Access Compliance Report

Public Rights-of-Way

| Intersection ID: 13600 | Main Street: 3RD-4TH_CONNECTOR_ST | Cross Street: E_4TH_ST | Location: | N |
| ADA ID: EF80BB9F486E | Ramp Type: Perp | Initial Pass/Fail: Fail | Overall Compliance: No | Severity Score: 12.5 |

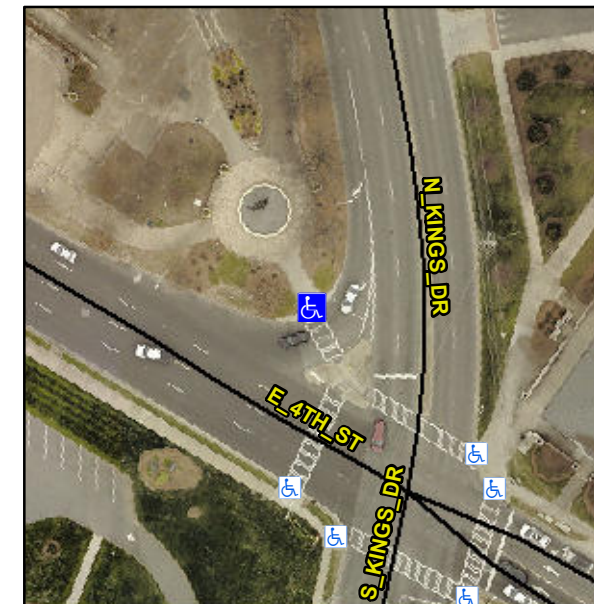
Possible Solutions:

Remove & Replace Entire Ramp.

PROW/ADA:

R304.2.2

| Compliance | Description | Data | Compliance | Description | Data |
|------------|-----------------------|-------|------------|-----------------------------|------|
| N/A | Ramp Length (in) | 72.0 | No | Ramp Slope (%) | 8.6 |
